PLAN AND ZONING COMMISSION

Meeting Agenda
Tuesday, April 8, 2025
6:30 PM

City Council Chambers
1250 SW District Drive, Second Floor, Ankeny, Iowa

2 **NORTH ELEVATION**
SCALE: 1/4" = 1'-0"

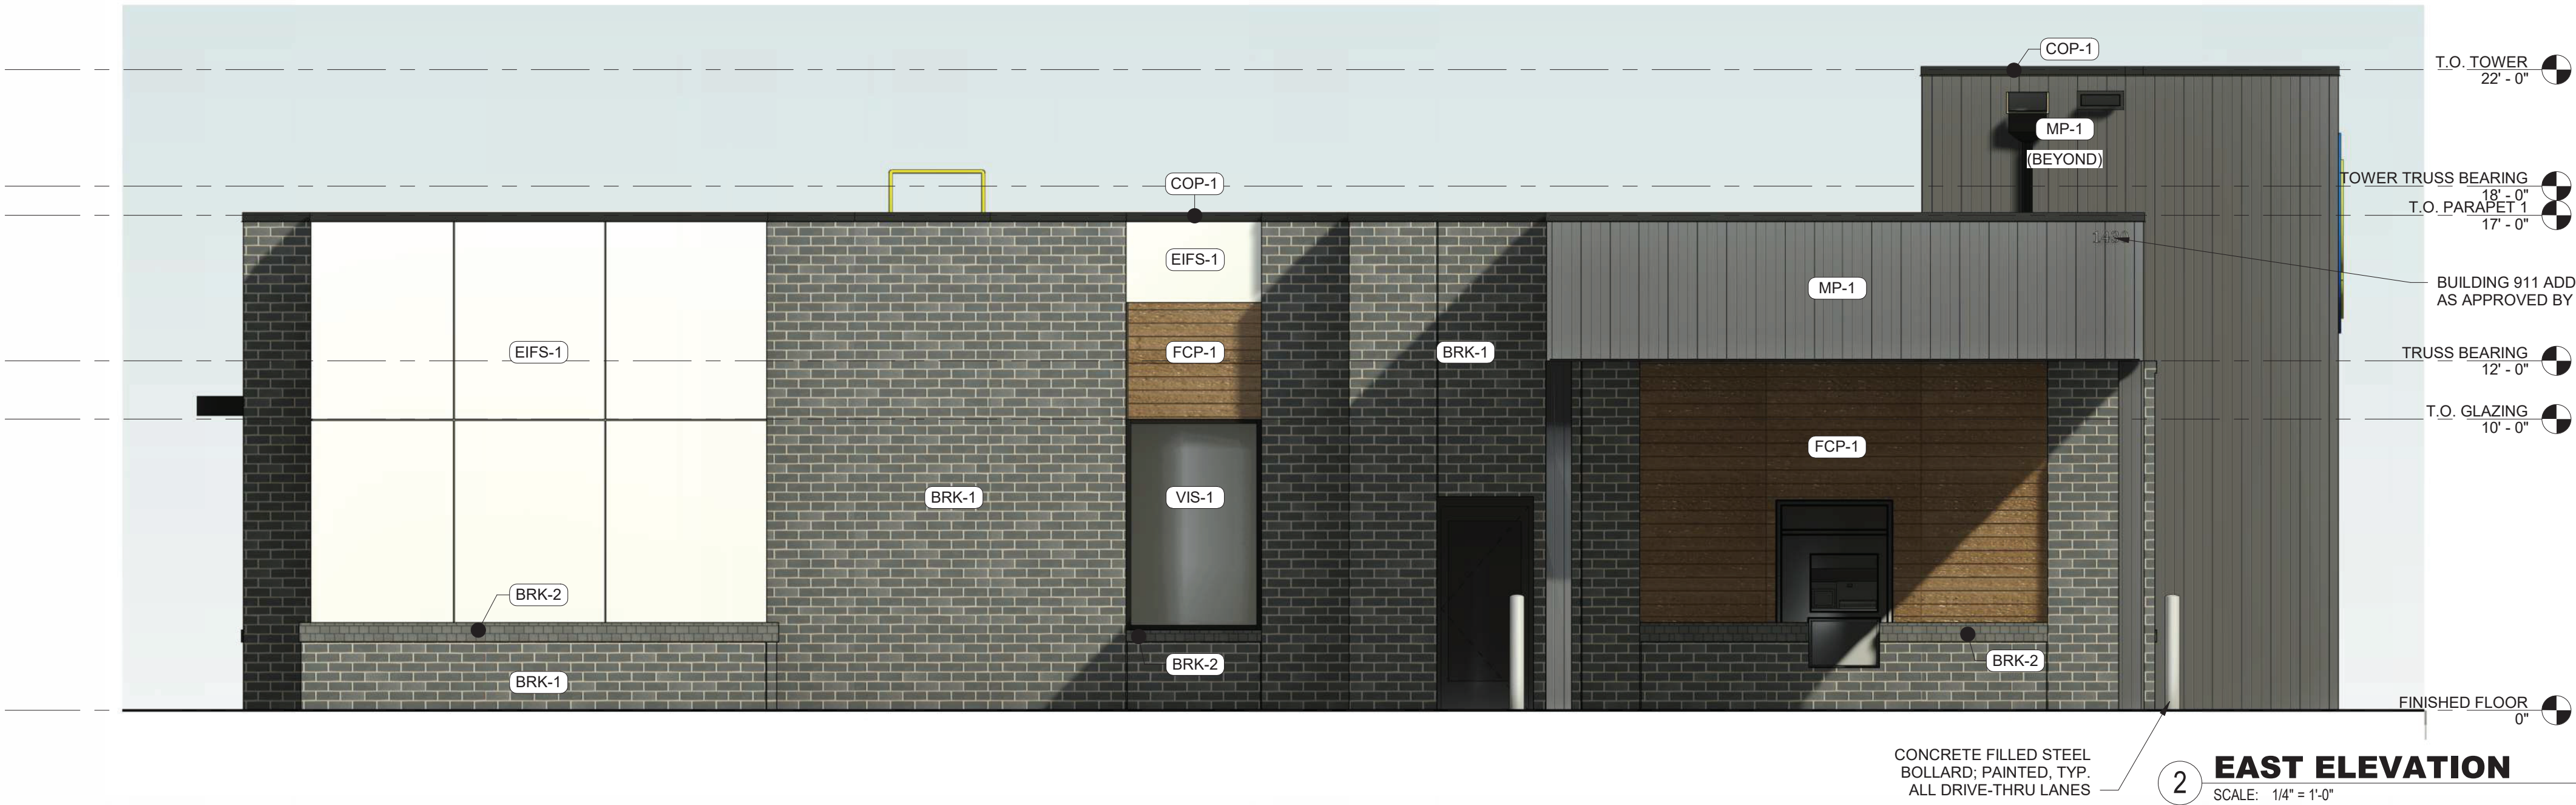
The Tradition PUD includes architectural guidelines that list acceptable building materials, however, the proposal shows metal paneling, which is not on the list of acceptable building materials included in the PUD. However, the property to the south has received a site plan approval to build a car wash, that proposal also shows metal paneling on the elevations. The proposed Premier Credit Union is compatible and complimentary of the surrounding area.
